1963 - 1965 Corvette: Service Bulletin: Drive Line Noise

Source: Chevrolet Technical Service Bulletin

Bulletin No: #1069

Date: January 7, 1965

FIGURE 1

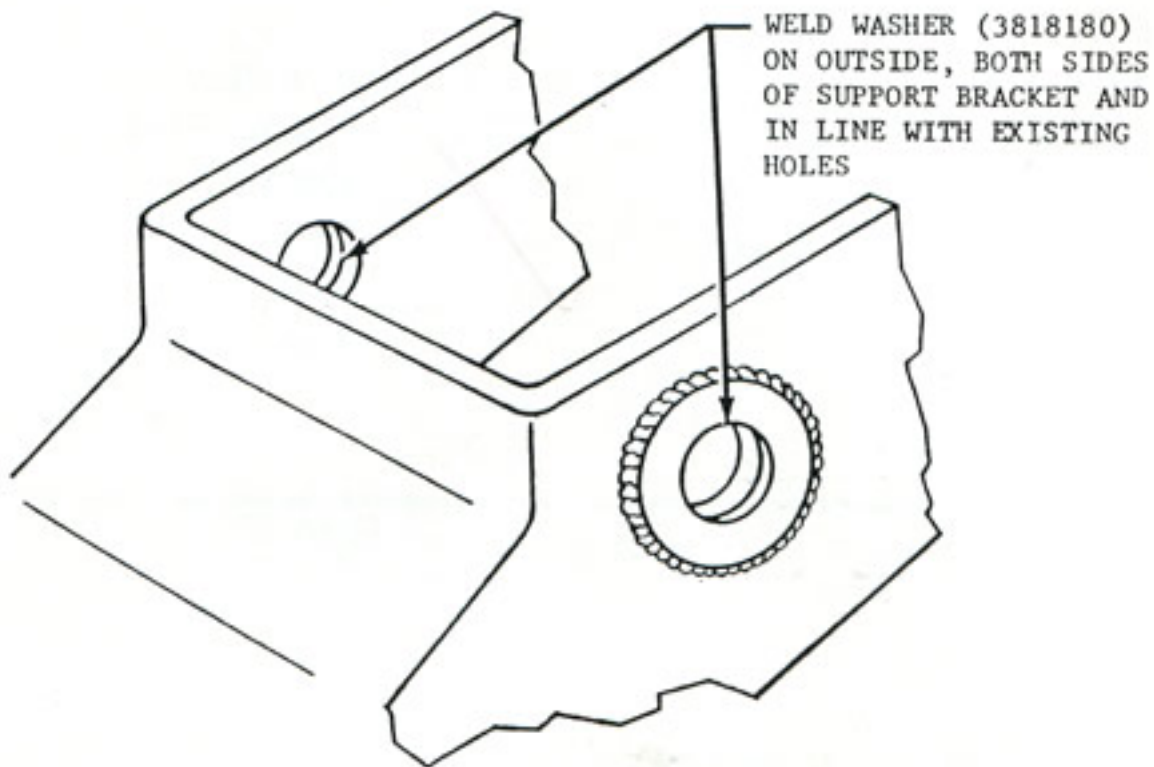
1. If reinforced bracket, Part No. 3868799 is not available, obtain Part No 3820186 and weld one flat washer, (Part No. 3818180) on each outside surface in line with existing holes (See Figure 1.)

FIGURE 2

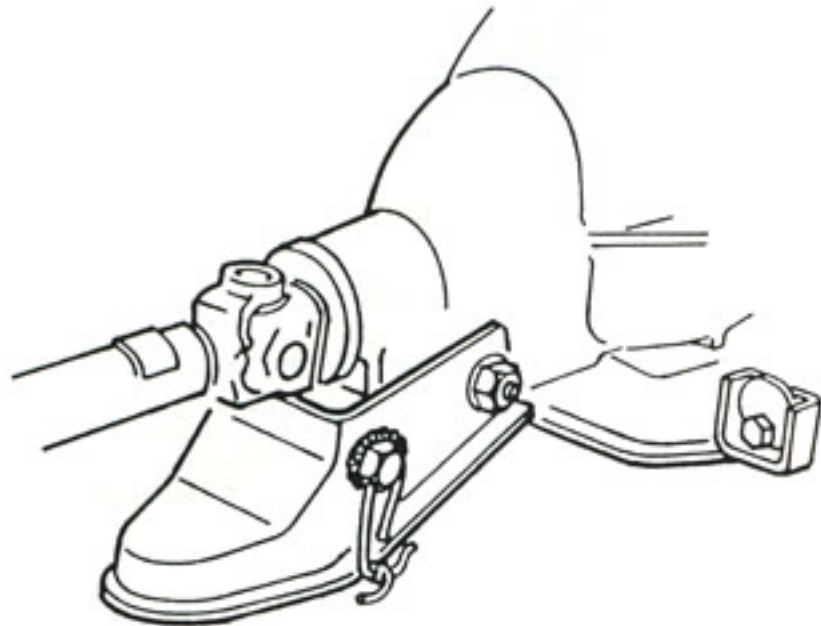
1. Obtain (2) 7/16-14 x 1 300M bolts and drill a 3/32 inch diameter hole through the head of each.
2. Drill a 3/32 inch diameter hole through the lower flange of the carrier bracket directly below the forward bolt hole (both sides of bracket).

3. Install new bracket using modified forward attaching bolts. Torque forward attaching bolts to 65 ft. lbs.
4. Safety wire the forward bracket bolts to the bracket with stainless steel safety wire (1/16 inch O.D.) or stainless steel welding rod (1/16 inch O.D.).

NOTE: Be sure the straight wire form the bolt head to the flange hole is on the tightening side of the bolt. (See Figure 2).

5. Tighten the wire sufficiently by twisting the ends together. NOTE: Over-tightening will cut the wire at sharp bends.
